## PRELIMINARY Author's reply to comments of reviewer #2 in AMTD

Figure 5. Just the graph below. In fig. 4a should be added new labels (as shown)

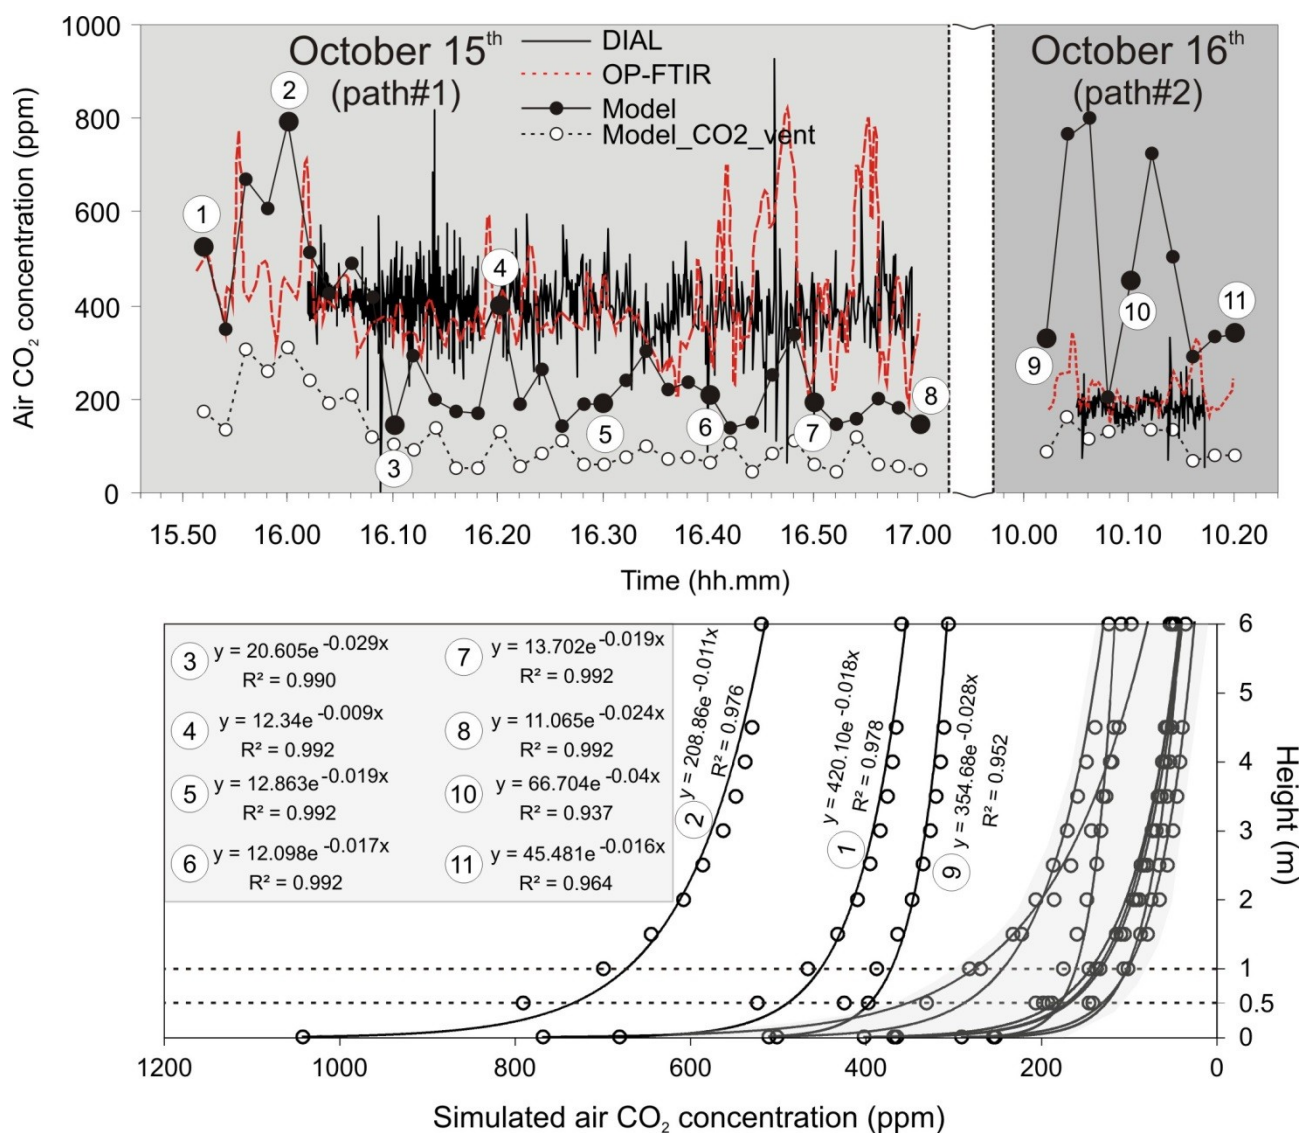
Another approach to evaluating the importance of the vertical gradient in CO<sub>2</sub> concentration might be to look at the model predictions for change in concentration with height above the ground. Unfortunately, though the authors state that a three-dimensional CO<sub>2</sub> map is produced by the model, no vertically resolved modelling results are given or discussed. Somewhere, rather late in the manuscript, the author mention that the vertical resolution of the model is 0.5 m. My feeling is that this may not be enough. The authors are encouraged to, if possible, increase the vertical grid resolution in the lower-most meters above the ground to try to capture the vertical concentration gradient. At least this way the importance of the effect could be assessed. In principle, the DIAL light path might even be sampled out of the vertically resolved model data if multiple heights were available along the path.

For the second part of this point I suggest to add a new figure (Fig.5) where we can show some vertical gradients derived from the numerical code. In figure 4a should be added new labels at selected times (15:52, 16:00, 16:10, ...17:00, 10:02, 10:10, 10:20, see below) in order to refer to those in fig. 5.

As expected, the predicted values of the CO<sub>2</sub> air concentration tend to exponentially decrease with the altitude, following the general equation:

$$y = a * e^{-bx}$$

where y is the height (in m), a (in m) the maximum altitude reached by the gas plume (i.e., the height where the plume density tends to match the air density), x is the air CO<sub>2</sub> concentration (in ppm), and b (in ppm<sup>-1</sup>) indicates how rapidly the CO<sub>2</sub> concentration decreases with height. Best fitting curves for the simulated layer (0–6m height) are reported in Figure 5, together with relative equations. The atmospheric layer affected by the gas dispersion ranges typically from 11 to ~70m (parameter a in the inset of Figure 5 referred to curves of the gray region), with the exception of conditions with high-speed winds blowing from W and SW, which raise the buoyant plume up to 200–400m (curves 1, 2, and 9)

With reference to 0-1m gradient we also believe that it's true, the concentration change is significant in the first metre since the curves decrease exponentially but this change is not dramatic

because of the high concentration of the plume, whose top is at 10-60 m above the soil or more and not just at 1 m as the reviewer said somewhere and that the value assumed at 0.5 m is a reasonable compromise, obviously underestimated for the DIAL (measuring from 1m to ground) with respect to the FTIR (0.5m).

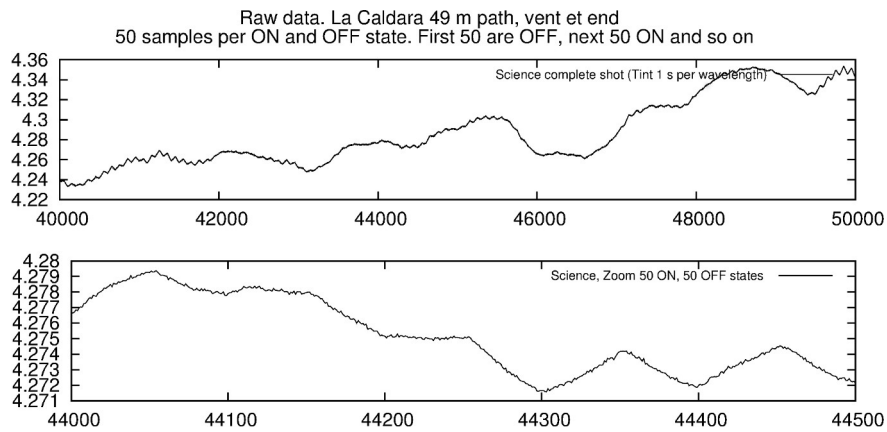
Comparing shorter term trends (within the instruments' time resolution) seems more interesting to me. And here there appear to be some pretty serious discrepancies. For example, on 15 October between 16:45 and 16:50, the FTIR measured a column amount between 600 and 800 ppm above background while the DIAL showed no increase whatsoever above the average value of 400 ppm.

Reply 9: There is a peak at 16:47 which has not occurred before, coinciding with the CO<sub>2</sub> concentration measured by the FTIR. Moreover, a second peak coincides with an increase in CO<sub>2</sub> as measured by the FTIR at 16:55.

As for the short term fluctuations after 16:20, it is unlikely that the DIAL was not capable of measuring variations of this order since we have done corresponding sensitivity tests with CO<sub>2</sub> before (see also Replies 13 and 14). The fact that positive changes are averaged out when using the full ensemble of 1e5 intensity ratios instead of a fraction of the data only means there were negative changes as well as positive, so that on average there was little change on scale of the DIAL integration time (2 s and 4 s respectively).

The figure above shows some raw science data from path #1. The first 50 samples correspond to OFF wavelength the next 50 to ON the next 50 to OFF aso. The oscillations are due to atmospheric turbulences. What becomes obvious when zoomed in (plot below shows 10 switch states) is the slope each state (ON or OFF) exhibits. For many states we can see this slope. If we compute the ratio between OFF and ON for each sample and average we get the flat time series with barely any small scale fluctuation. Now, before we compute an intensity ratio we can boxcar the samples, meaning we only chose to take the samples between sample 17 and 47, for instance. If we set the boxcar such that we chose the first few samples only we get a time series that follows the standard deviation in Fig. 4b., if we chose the last few samples only we get a time series that is almost anti-correlated to that one. We have no good explanation for this.

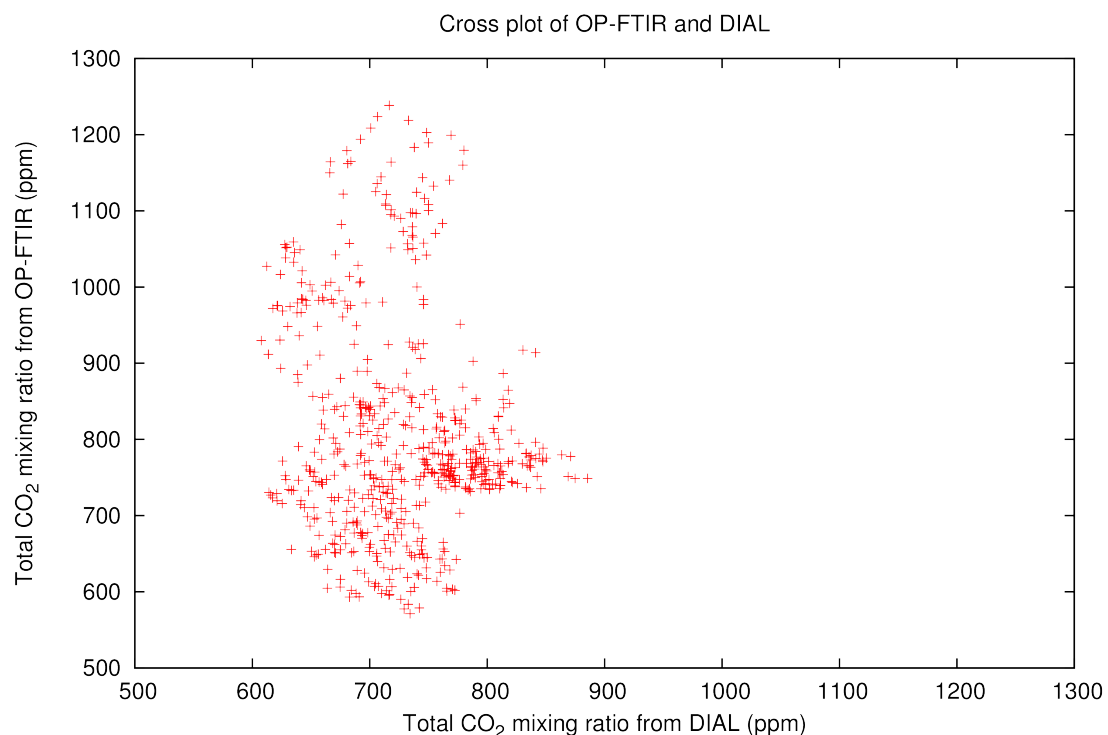
This appears to be true in several other time periods as well. Could you please include a figure plotting the DIAL measurements (perhaps smoothed to the time resolution of the FTIR) vs the FTIR measurements?

Can you fit a straight line through those? What is the confidence of that fit? Is the correlation statistically relevant?

This figure shows a cross plot for the data of path 1 for the last 40 min of data using only data between sample 44 and 45 per ON and OFF state (Figure 4bis above). As expected there is an imbalance for the higher concentration from FTIR which are not matched by the DIAL.

Reply 11. Exactly. See also Reply 2. However, I still computed the Pearson cross-correlation coefficient, which is (for the data as shown in the discussion paper):

Path #1, 15 October: 0.07 (0.11 all pair, 0.03 with smoothed) (16:00 to 16:18), 0.09 (0.1 all pairs, 0.11 smoothed) (16:20 to 17:00)

Path #2, 16 October: 0.06 (0.14 with smoothed)
